Department of Transportation
Division of Highway and Bridge Maintenance
360 Lincoln Avenue
Warwick, RI 02888

Subject: Physical Alteration Permit (PAP) Applicability Request
485 High Street, South Kingstown

RE: Request for Applicability for Bell Capital, LLC. for a project located at 485 High Street in South Kingstown, Rhode Island

PROPOSED CONDITIONS PLAN FOR
ERIC BELL
LOCATED AT
ASSESSOR'S PLAT 48-3, LOT 147
485 HIGH STREET
SOUTH KINGSTOWN, R.I.

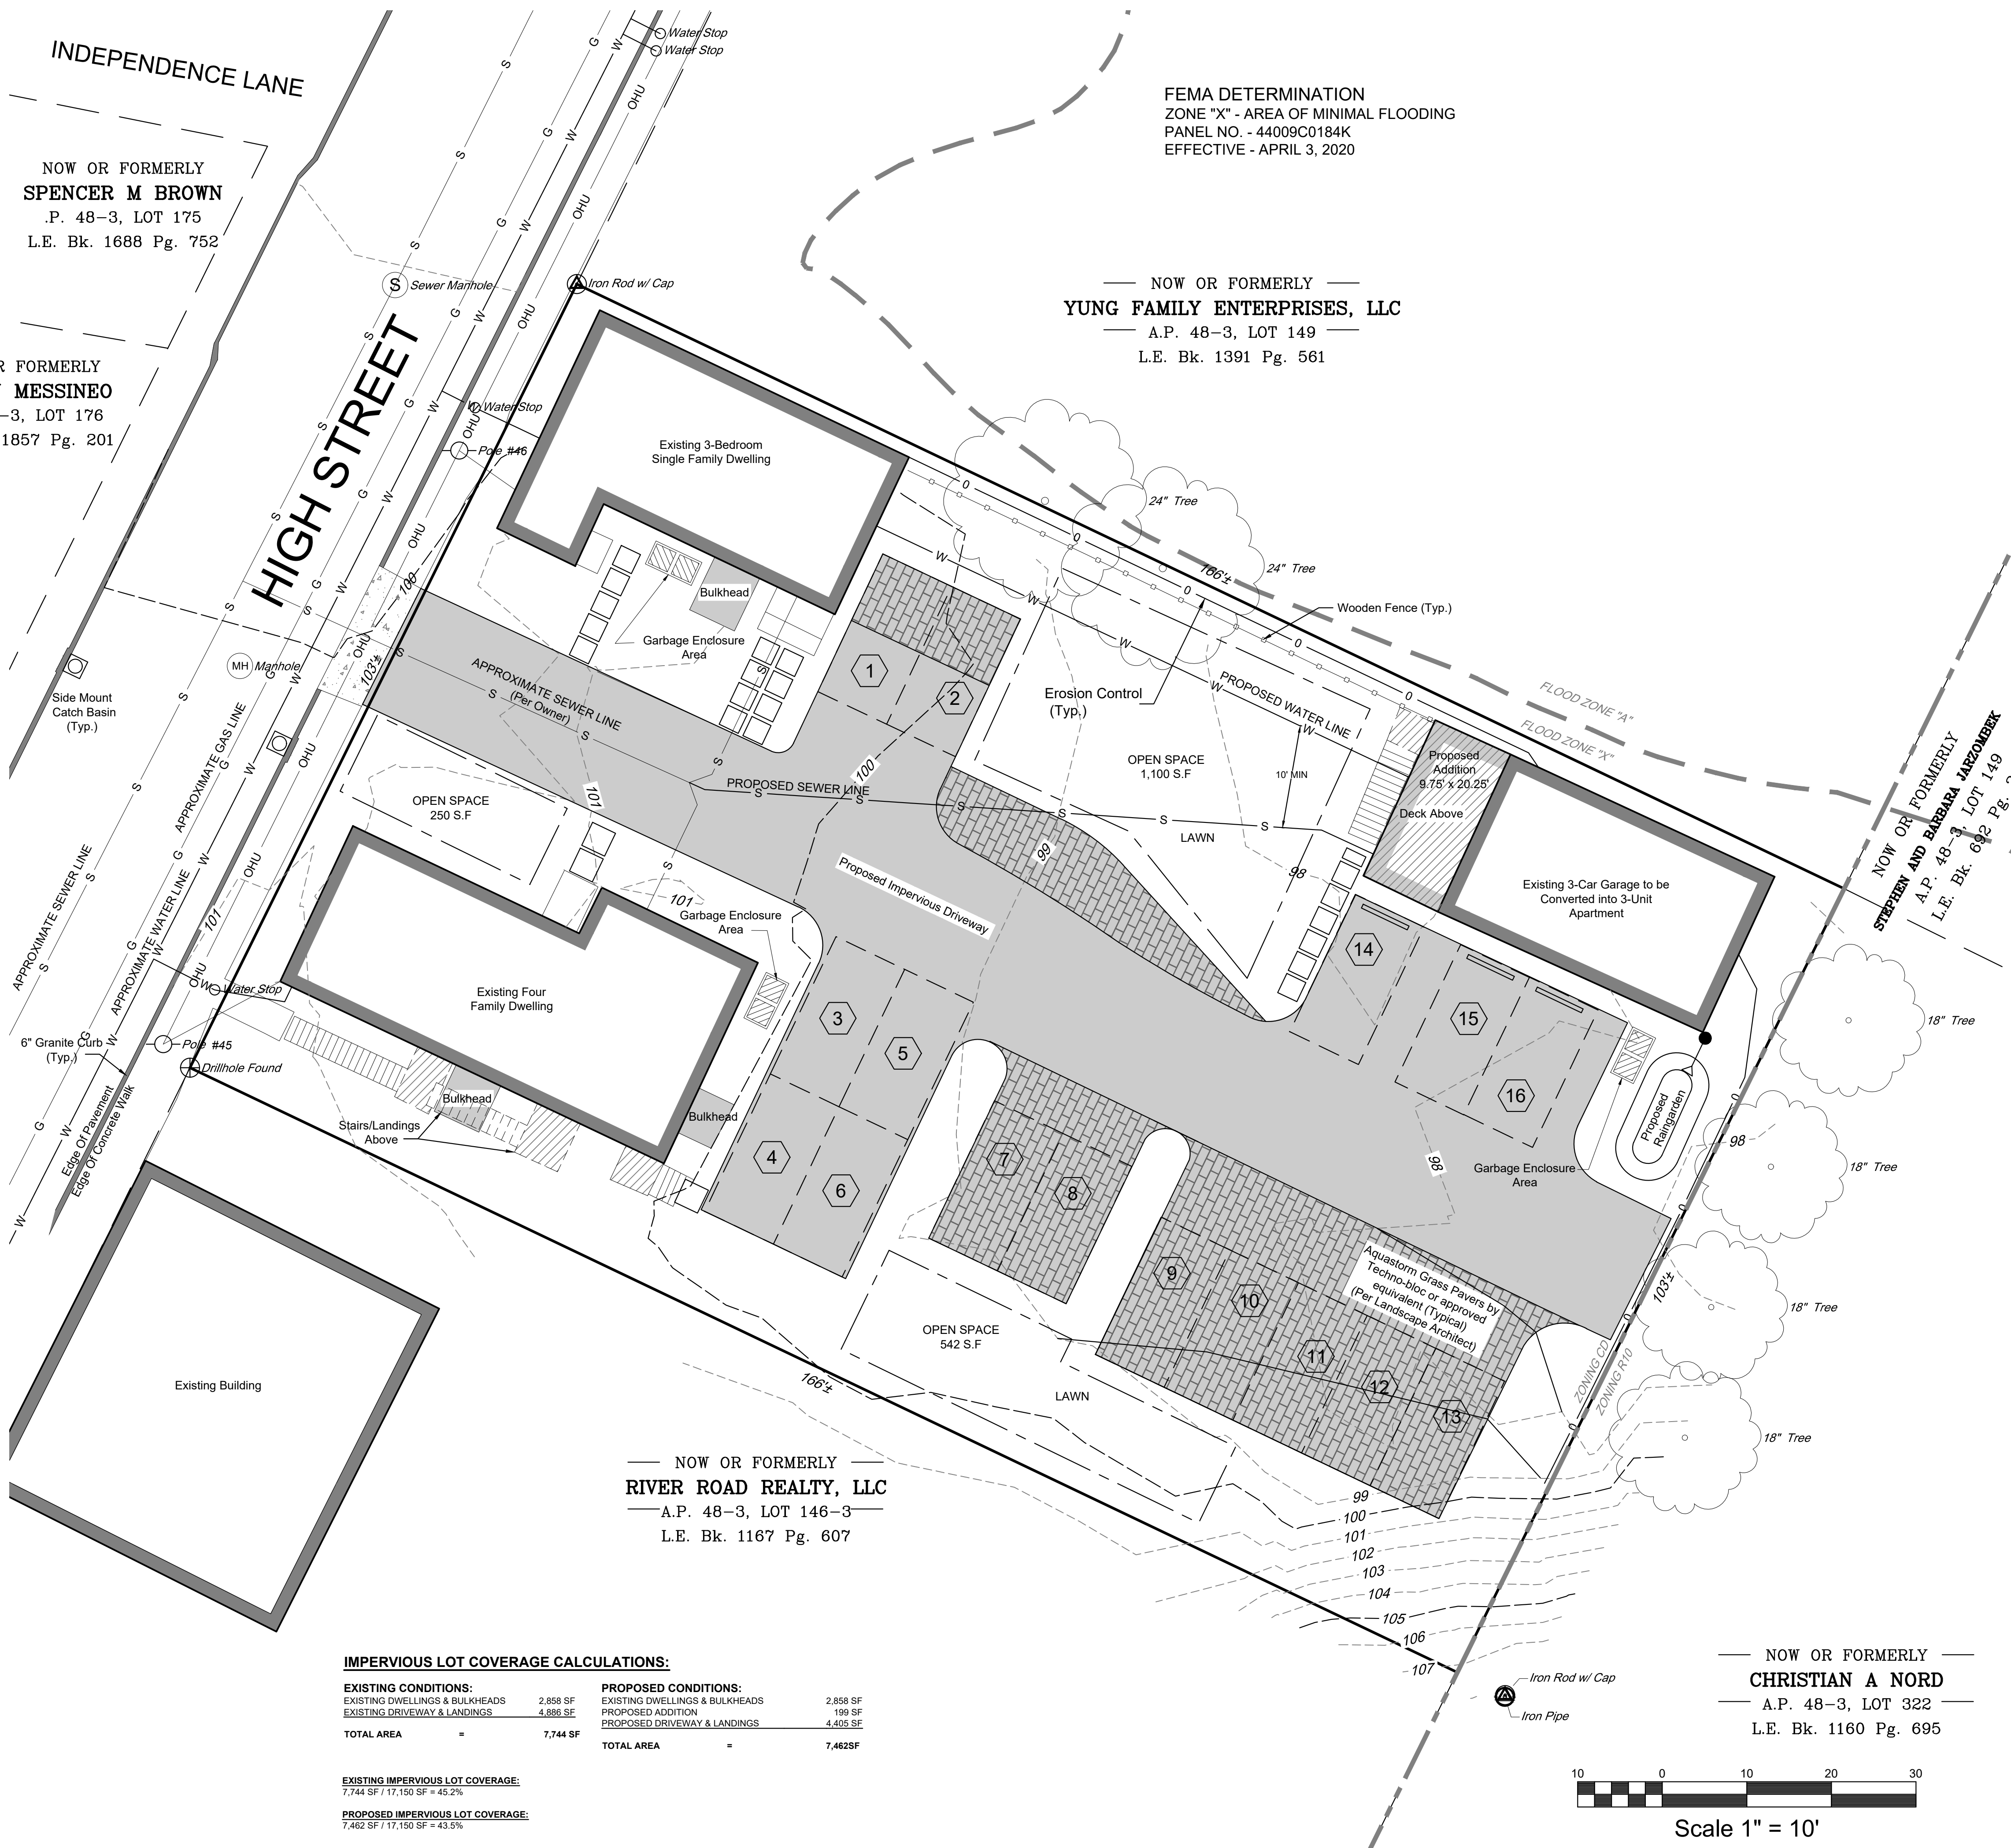
Your letter states that as part of the development, the existing concrete parking lot will be removed and replaced as shown on the site plans. The site plan shows a proposed impervious driveway and calls for the use of grassed pavers. The proposal notes that the driveway will match the existing sidewalk panel joint, and that no work is proposed in the State Right of Way. The plans list a reduction of 282 SF of impervious lot coverage for the proposed conditions. The letter also notes that the grassed permeable pavers will reduce impervious areas, and reduce runoff rates and volumes, and that there will be no increase in stormwater runoff to the State Highway as a result of this project.

With that said, based on the information provided, we have determined that a Physical Alteration Permit is not required. If the project scope changes and results in any potential impacts to the State Highway Right-of-Way (ROW), please let us know so we can review and provide more guidance if necessary.
